**COALFIELD DEVELOPMENT CORPORATION
CABELL COUNTY, WEST VIRGINIA
JUST TRANSITION CENTER
ADDENDUM # 3
February 18, 2026
THRASHER PROJECT # T60-11108**

A Pre-Bid Conference was held on Tuesday, February 3, 2026, on the above-referenced project. The following are clarifications and responses to questions posed by contractors for the above-referenced project.

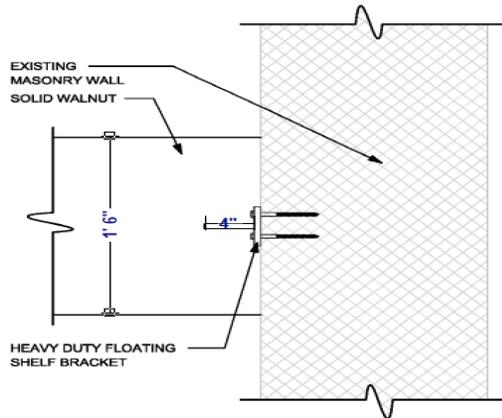
Where on the Plan Sheets does this apply?

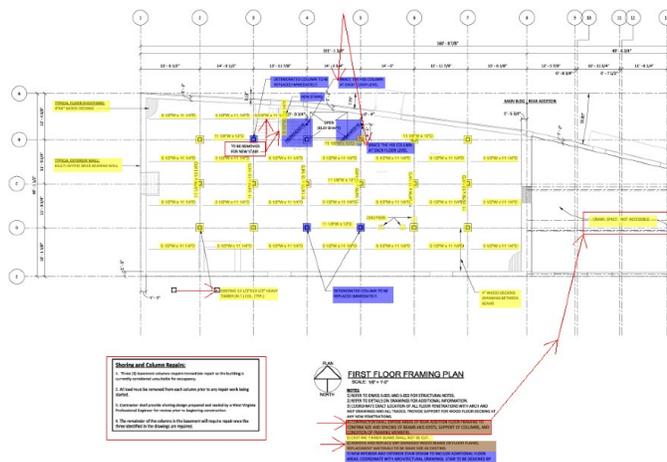
On Sheet S-600 photos 4 and 9 are the only areas requiring masonry infills. Will there be a Unit Price/brick be provided for additional brick replacement, if required, or a Quantity allotment be added to the base bid?

An allowance and unit cost for brick replacement has been added in the revised spec included in the addendum.

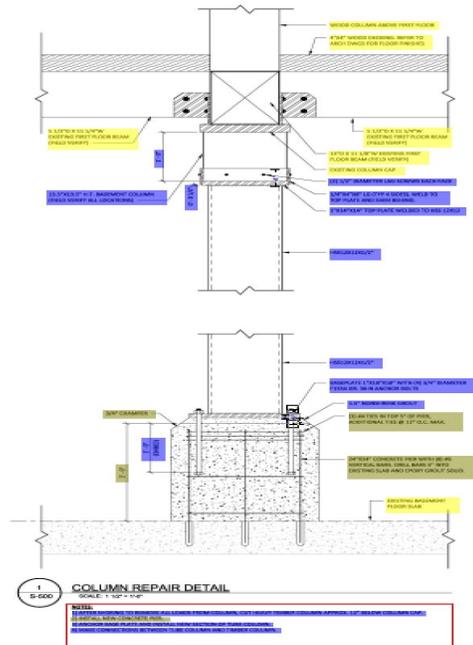
Referring to Sheet S-500 Structural Details, detail 1/S-500 Column Repair Detail Wrapping the top of the beam and installing the column over the embedded anchor bolts within the crawl space will be extremely difficult with only a 1-1/2" grout space. Would one of the two options be permitted. Allow a 3" grout space and/or allow for the 3" anchor bolts to be drilled and epoxied into place.

ROOF FRAMING PLAN

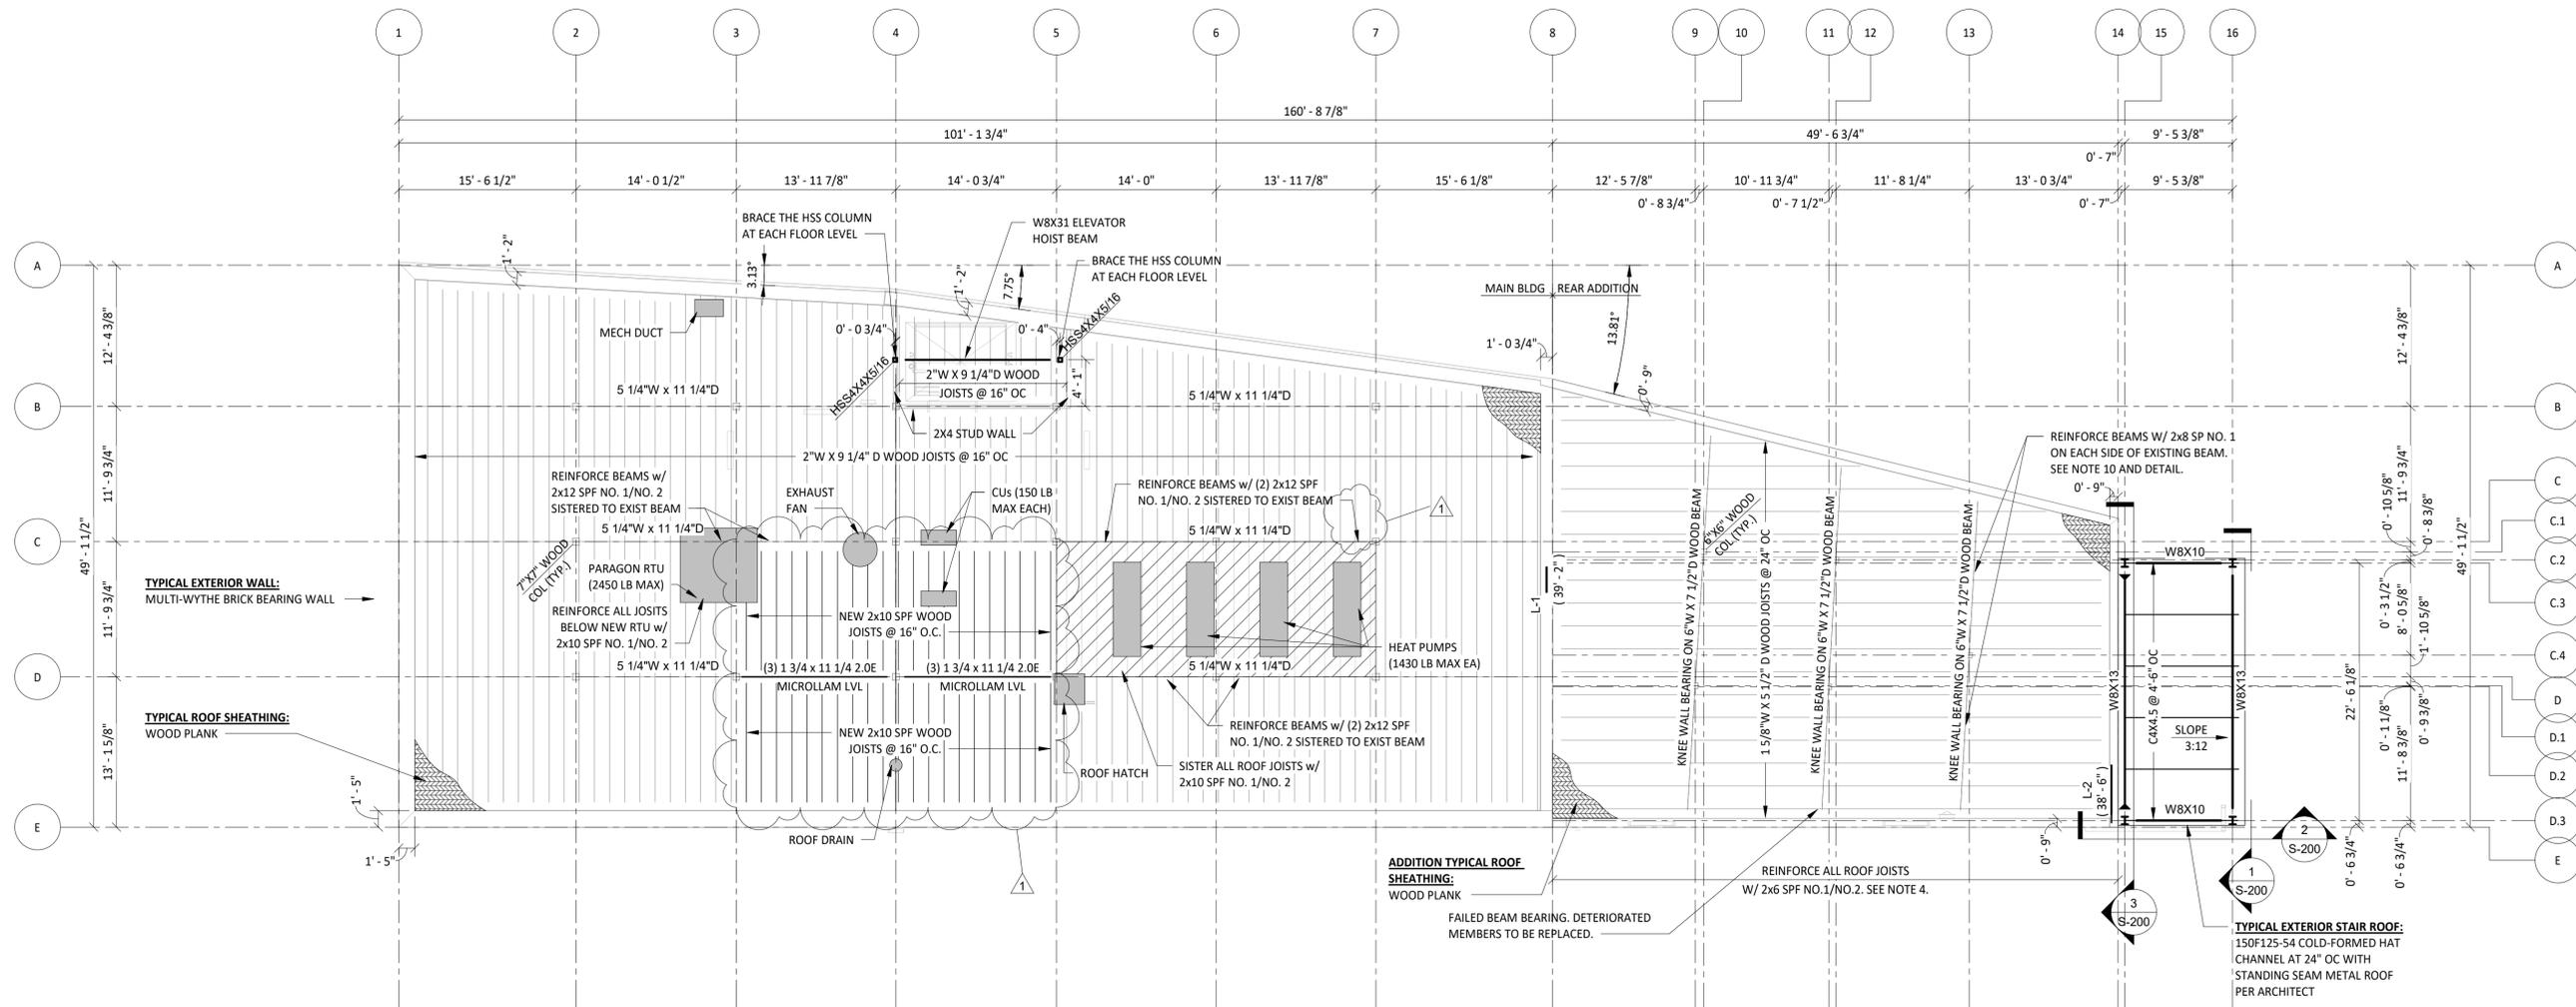
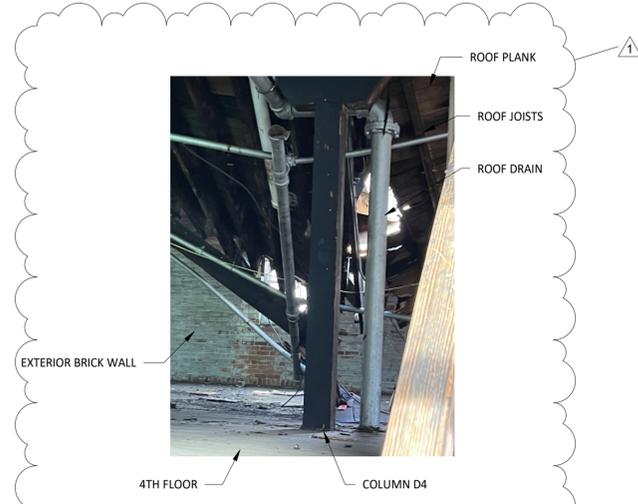
Referring to Sheet S-105 Note 05 Install new columns in rear addition as shown.

The locations of the column appear to be vague. Appears to be (6) six columns. Is this correct?

Delete note 5 on Sheet S-105. There are no new columns in the rear addition.
